100 LEVEL FLOOR PLAN
SCALE: 1/16" = 1'-0"

LINCOLN PLACE
1801 WASHINGTON AVENUE
MIAMI BEACH, FLORIDA

A3.1

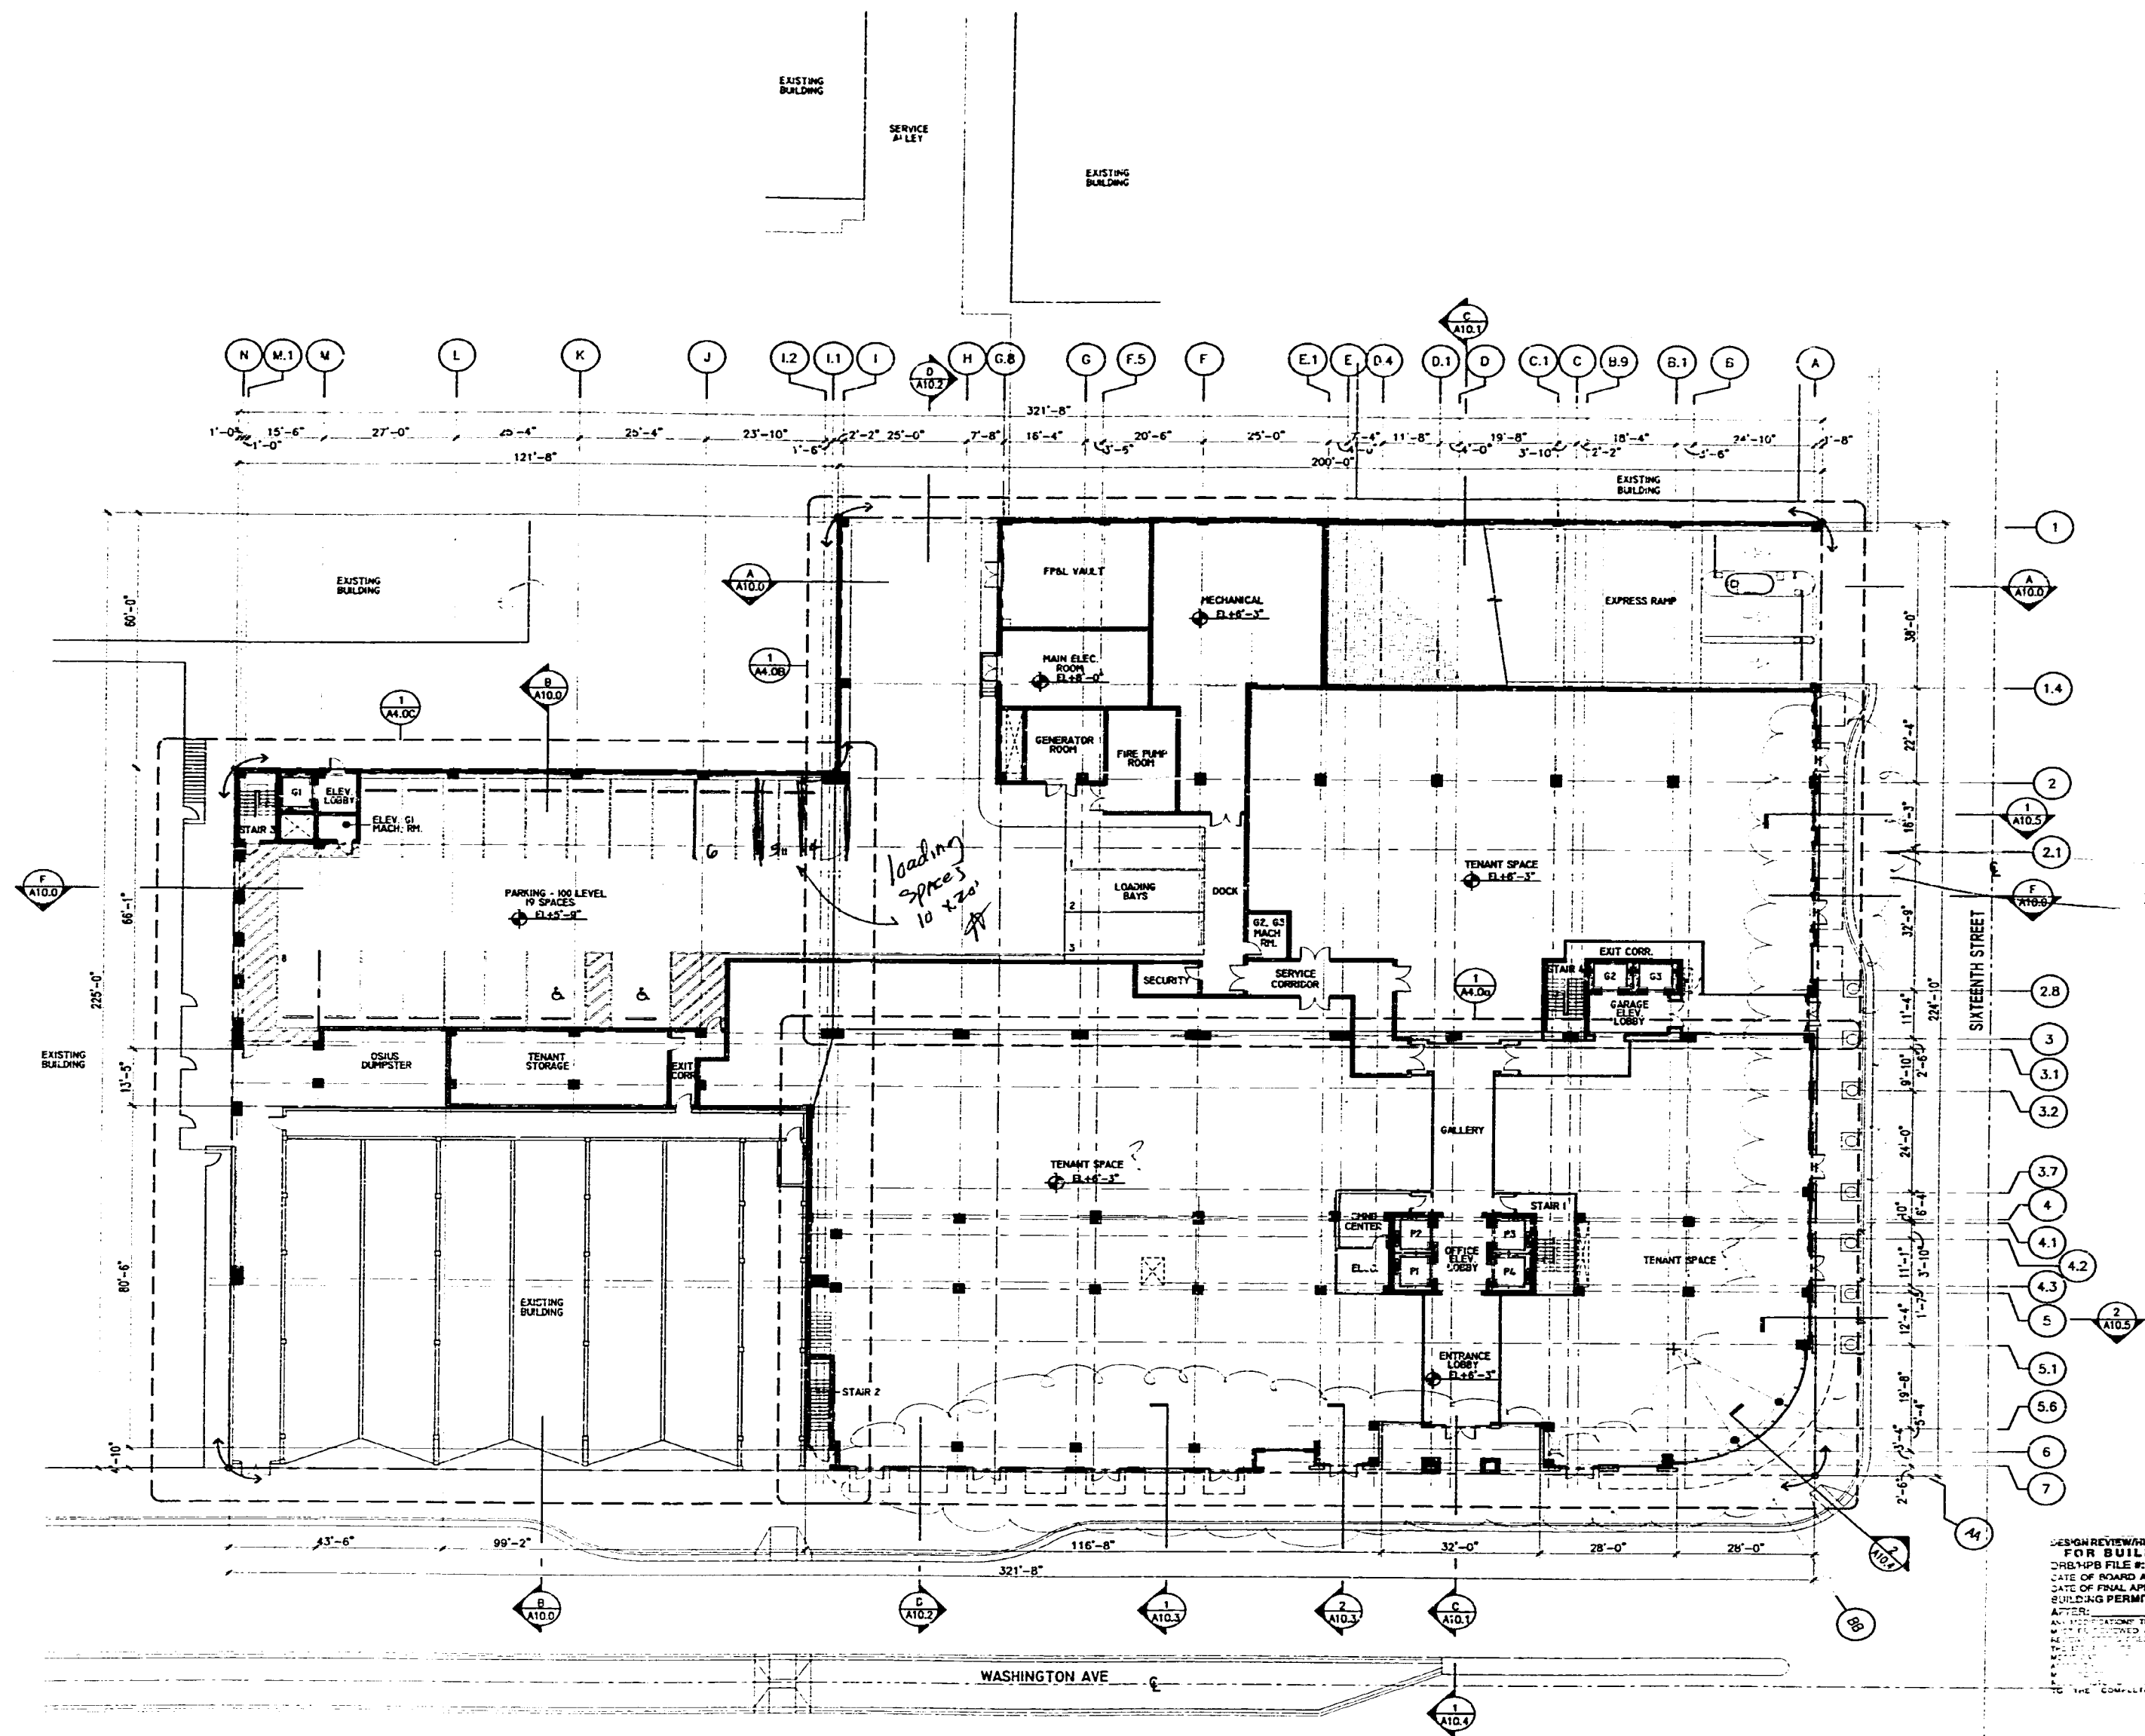
STREET LEVEL DOORS
TO BE RECORDED BACK
OF PROPERTY LINE - ON
SOUTH SIDE SUBJECT TO
THE APPROVAL OF THE
CITY OF MIAMI
APPROVED AS NOTED
DATE 10/20/2009
BY [Signature]
